CITY OF ST. HELENS PLANNING DEPARTMENT

MEMORANDUM

TO: Planning Commission acting as the Historic Landmarks Commission
FROM: Jennifer Dimsho, AICP, Associate Planner
RE: Architectural Character Review at 325 Strand Street
DATE: June 4, 2024

1 EAST ELEVATION (STRAND ST FACADE)
3/32" = 1'-0"

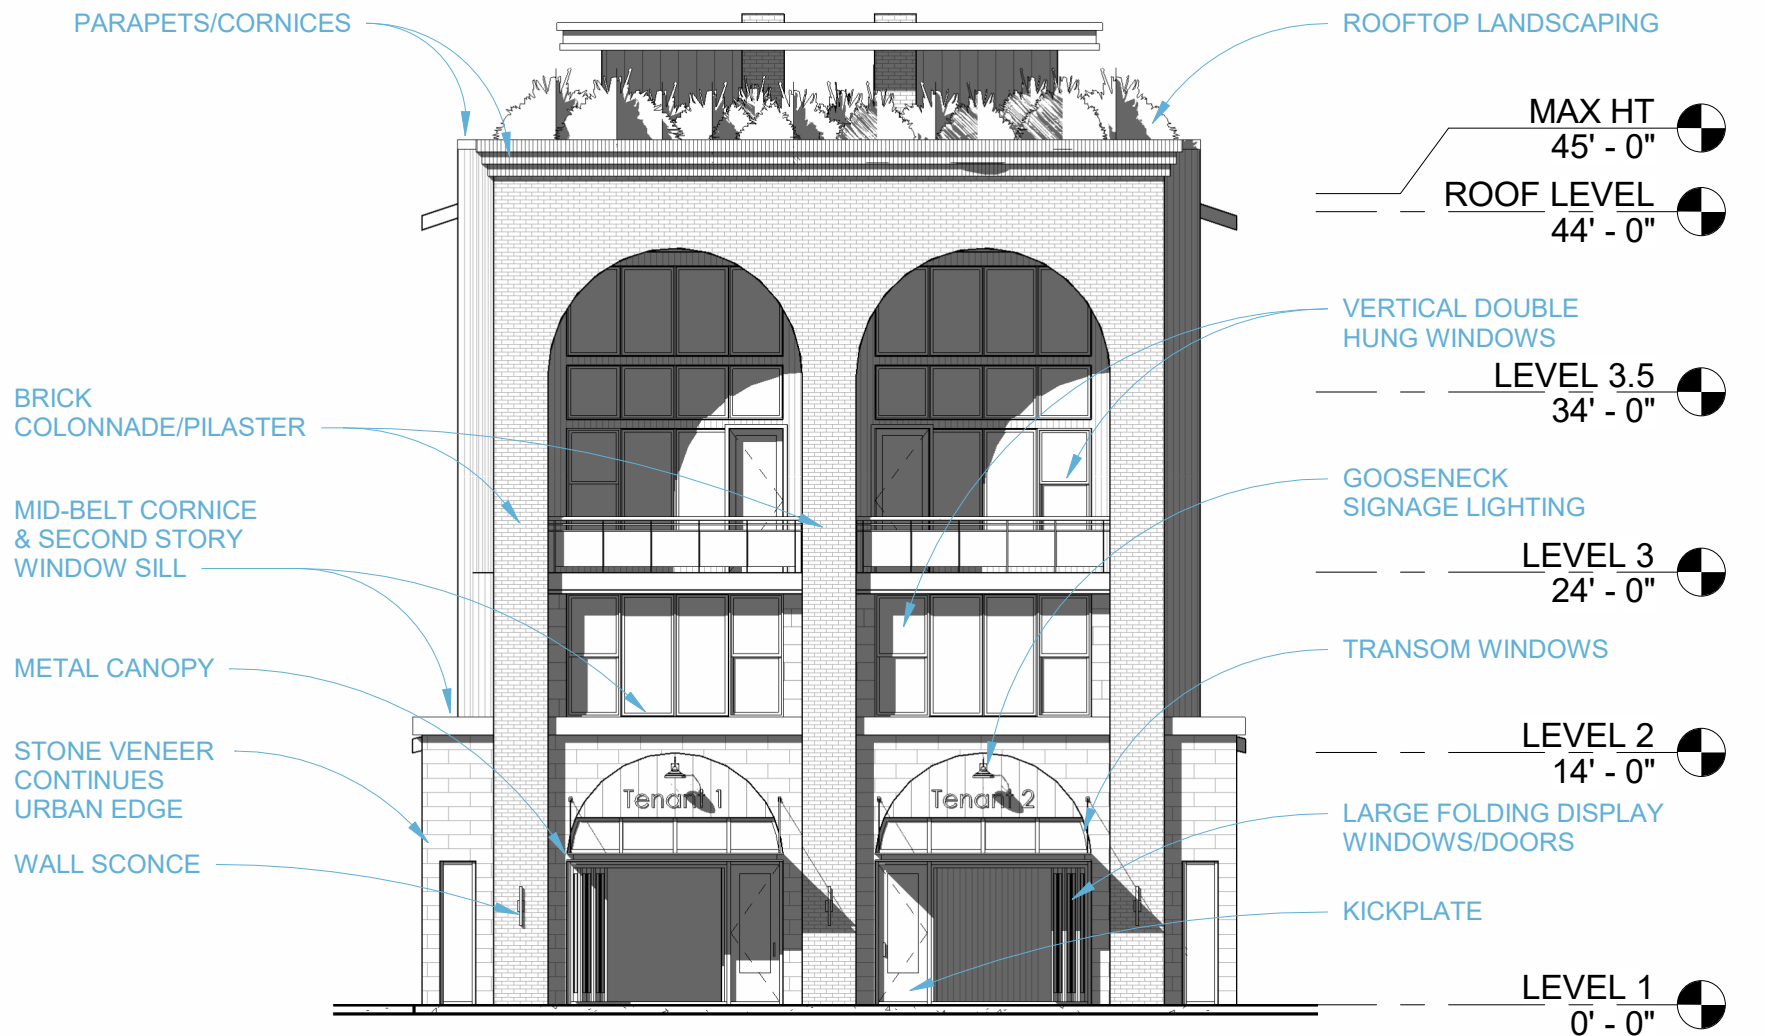
windows are not elsewhere downtown. There are no kickplates at the base of the display windows on Strand either; it appears the windows fold open and they extend all the way to the ground. **Does the Commission want to recommend replacement of these ground-floor folding display window to something more traditional with a kickplate at the base?**

The preferred gooseneck lighting fixture has been incorporated into the commercial units above their signage. The Guidelines recommend installing partially or fully shielded light fixtures which only emit light downward. There are proposed wall sconces on Strand Street. These can sometimes be directed upwards. **Does the Commission want to include a condition that the sconce lighting be directed downwards or that they be partially or fully shielded?**

There are various uses of wood siding, both vertical and horizontal. The narrative states this will be either shiplap or lap finished. The colors are all shades of browns and black. Staff feels this complies with the recommended neutral color palette. There is metal roof and siding proposed as dark black and brown. It appears that on both the south and north elevations, there is a significant portion of windowless siding that makes up almost the entire elevation on the ground level. **It's unclear if this is wood or metal siding.**

1 WEST ELEVATION (S. 1ST ST)
1/16" = 1'-0"

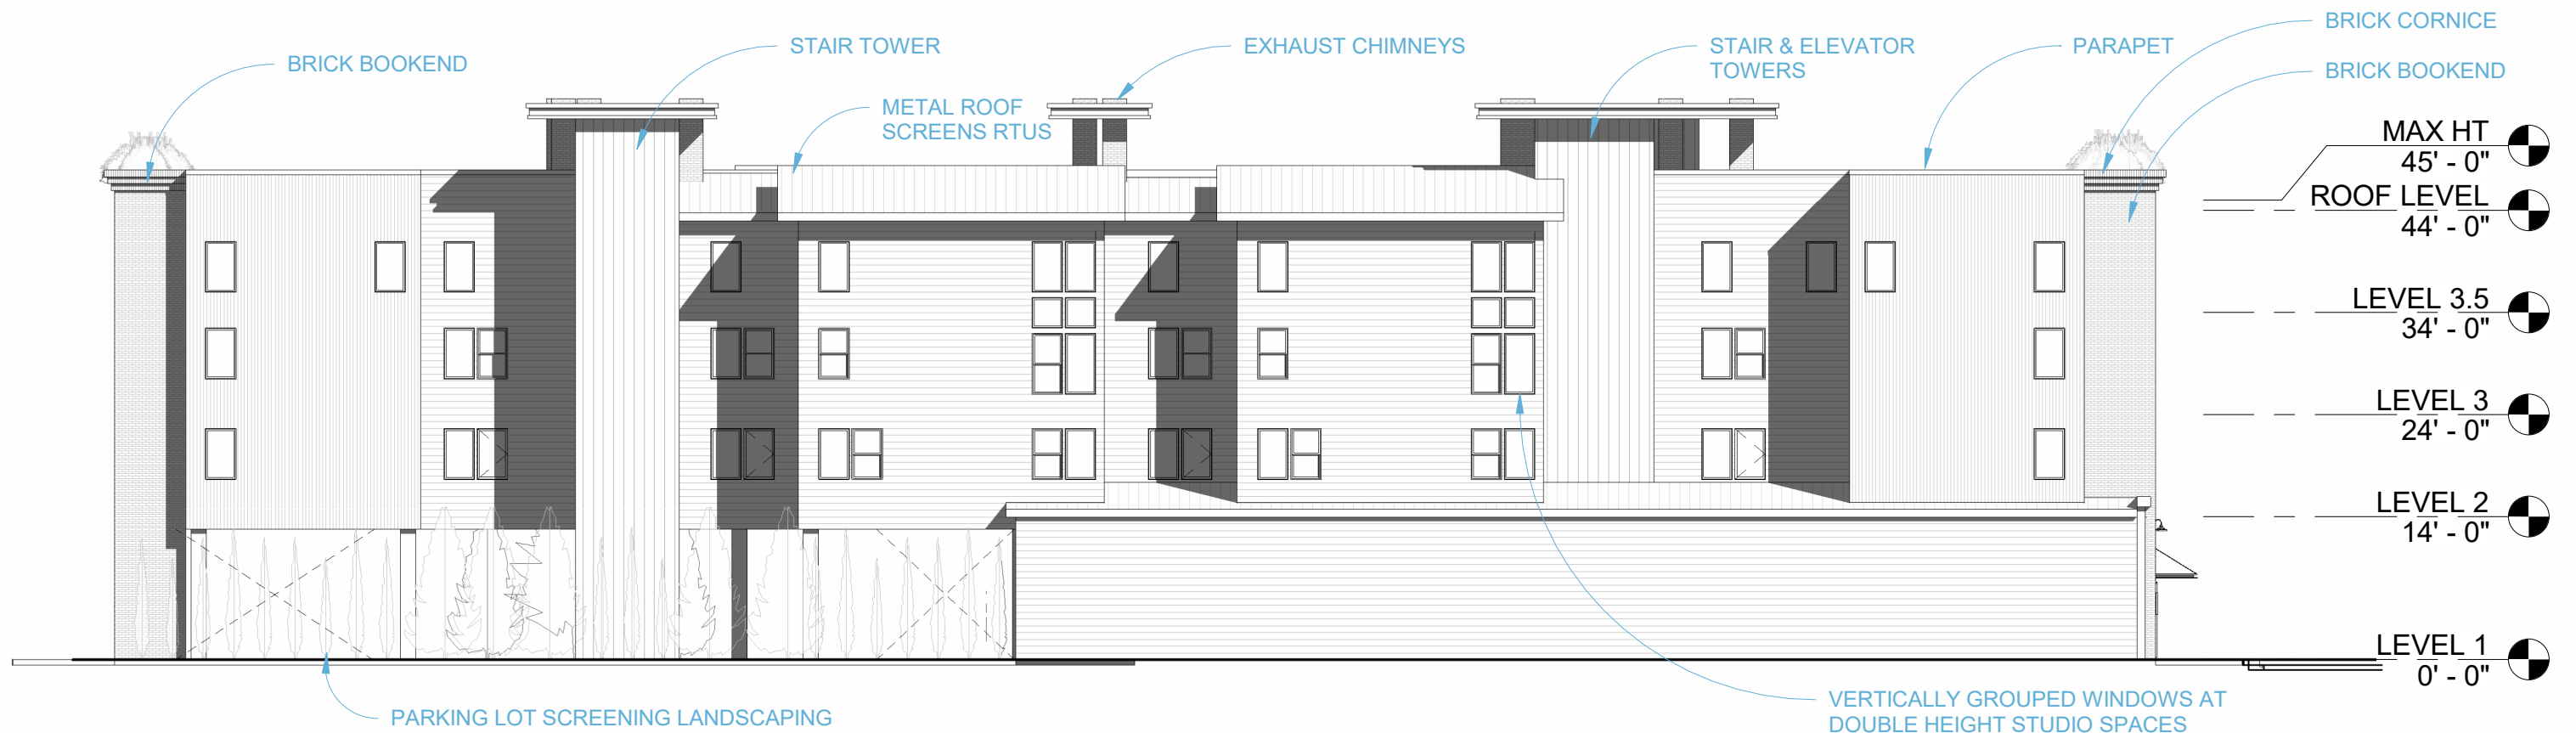
nearly 200' and they have broken it up into smaller masses with recesses and extensions, as well as changes in the roof line. **Does the Commission agree?**

For the storefront side, the applicant incorporates storefront windows with transoms. **The large folding display windows are not necessarily traditional and do not incorporate a window kickplate, which was also discussed under Building Façade/Entry. Does the Commission want to recommend a change here?** Overall, the upper floor windows are more vertically oriented, although they are not necessarily symmetrical or continue/match the neighboring property, nor do they match traditional wall-to-window ratio. The applicant is likely trying to maximize the view of the river on the Strand Street side by including more windows to walls. Although a similar design is used on S. 1st Street. **Does the Commission want to recommend a more traditional wall-to-window ratio on the street frontages?** Both the south and north elevation have a more traditional window spacing and wall-to-window ratio.
